Oyster Creek Nuclear Generating Station  
Renewed Facility Operating License No. DPR-16  
NRC Docket No. 50-219

Subject: Second Six-Month Status Report in Response to March 12, 2012 Commission Order Modifying Licenses with Regard to Requirements for Mitigation Strategies for Beyond-Design-Basis External Events (Order Number EA-12-049)

**Second Six-Month Status Report for the Implementation of Order EA-12-049, Order  
Modifying Licenses with Regard to Requirements for Mitigation Strategies for Beyond-  
Design-Basis External Events**

Attachment 1. Updated Conceptual Design Drawings

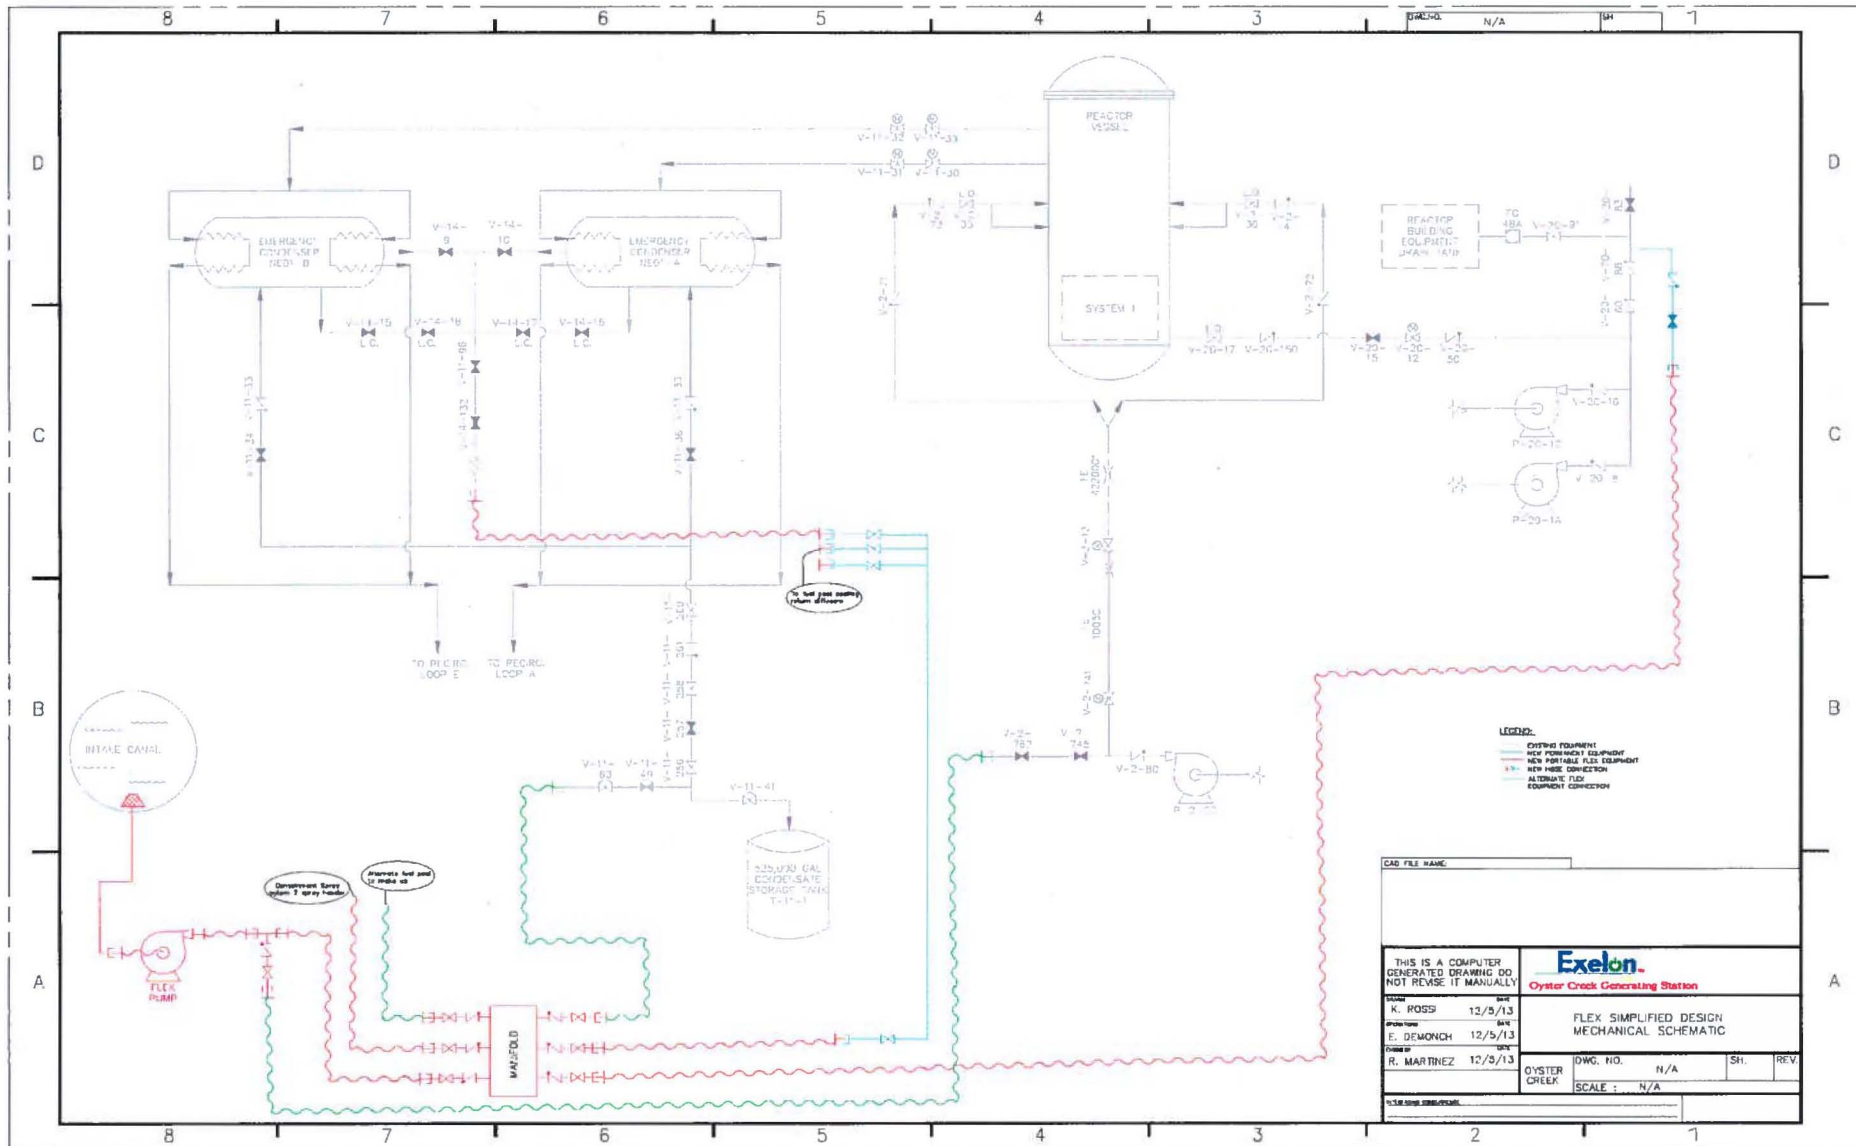
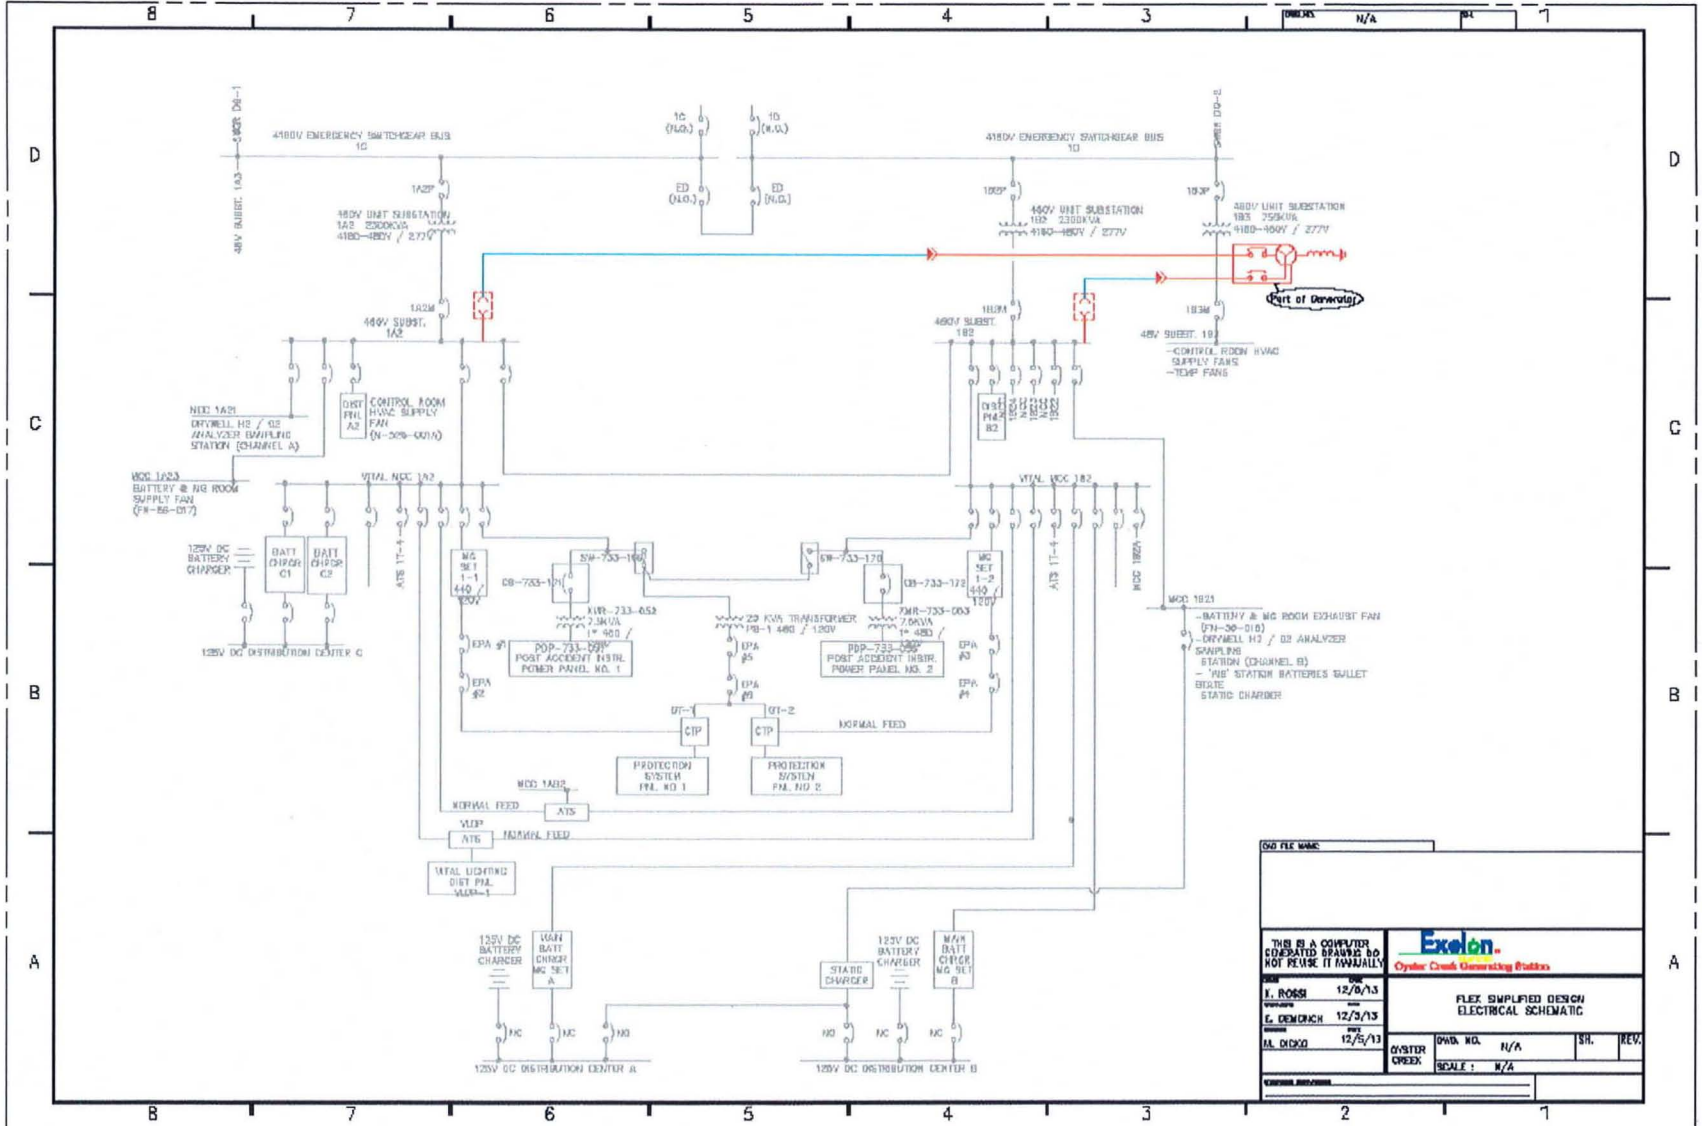
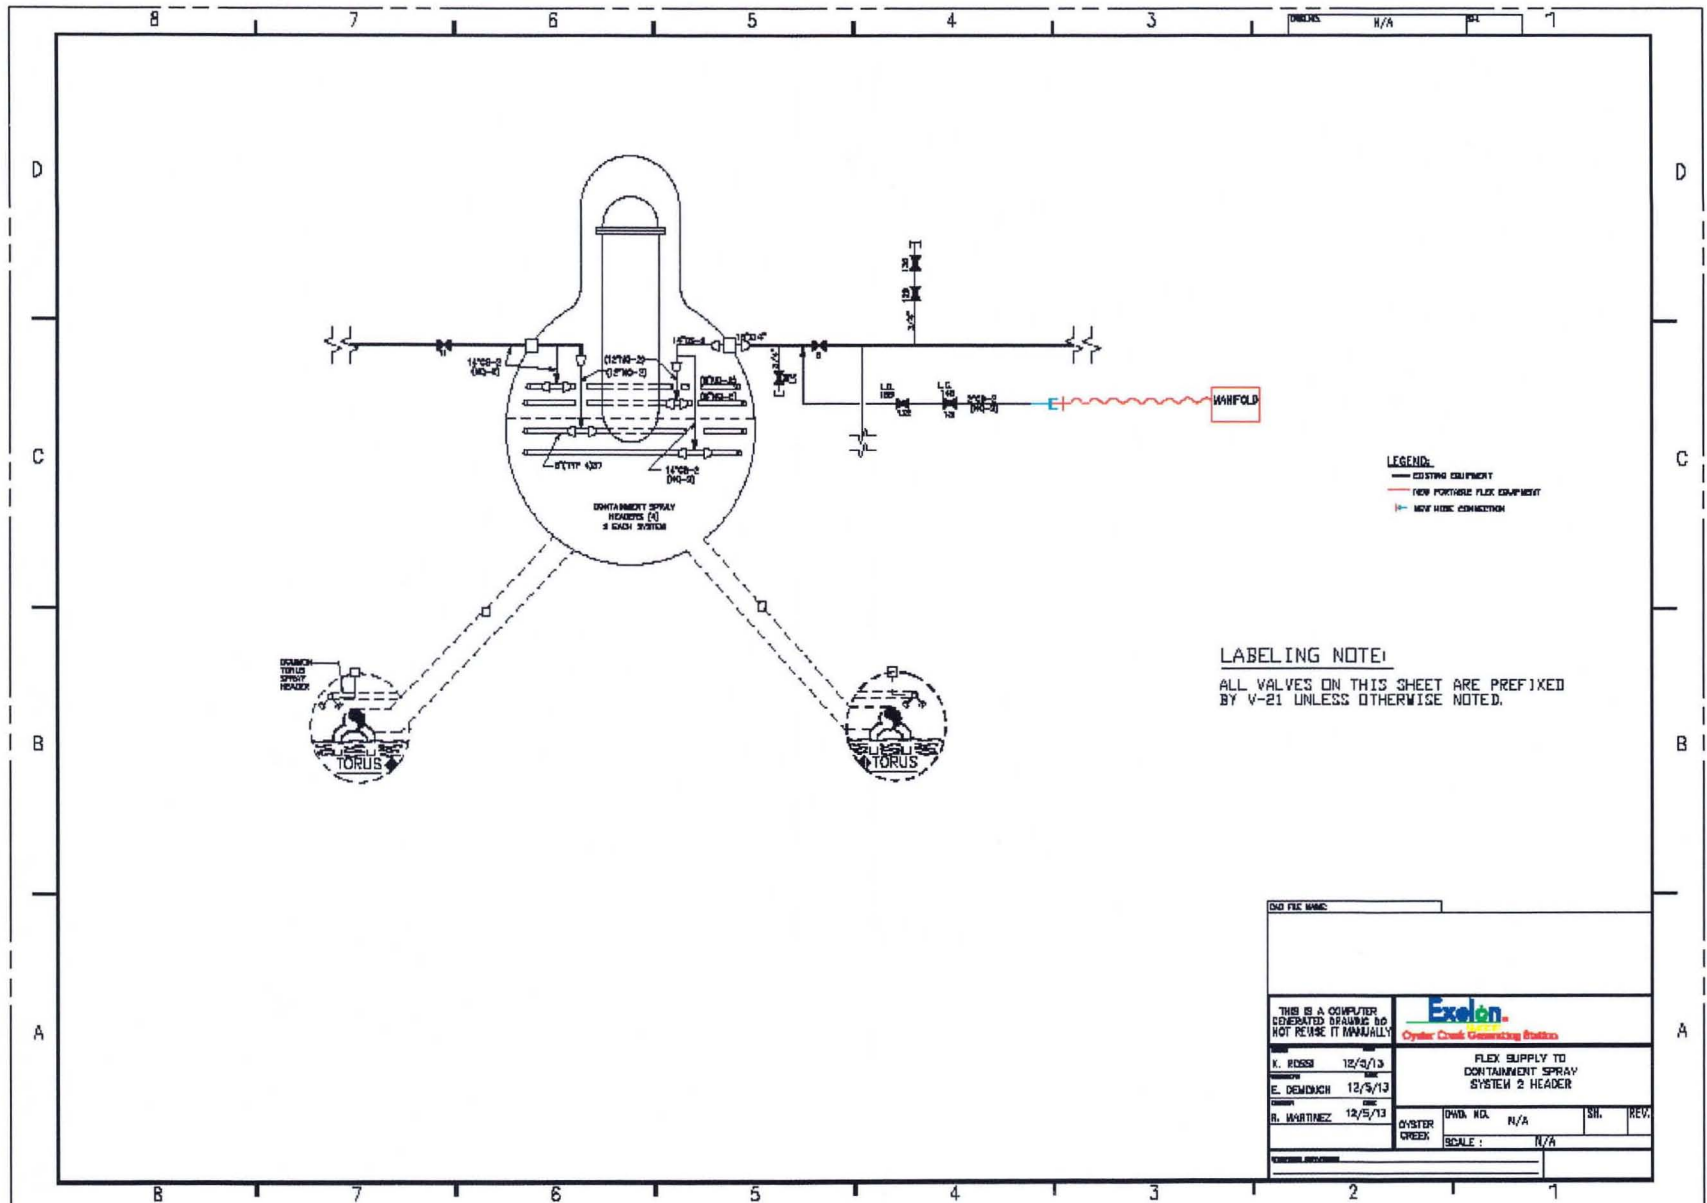
1. Updated conceptual drawing set to clarify and correct submitted OIP drawings.  
Added conceptual drawings for Containment Spray System 2 connection from the FLEX manifold.  
Added the drawing for Fuel Oil transfer connections from the protected / credited Fuel Oil tank.
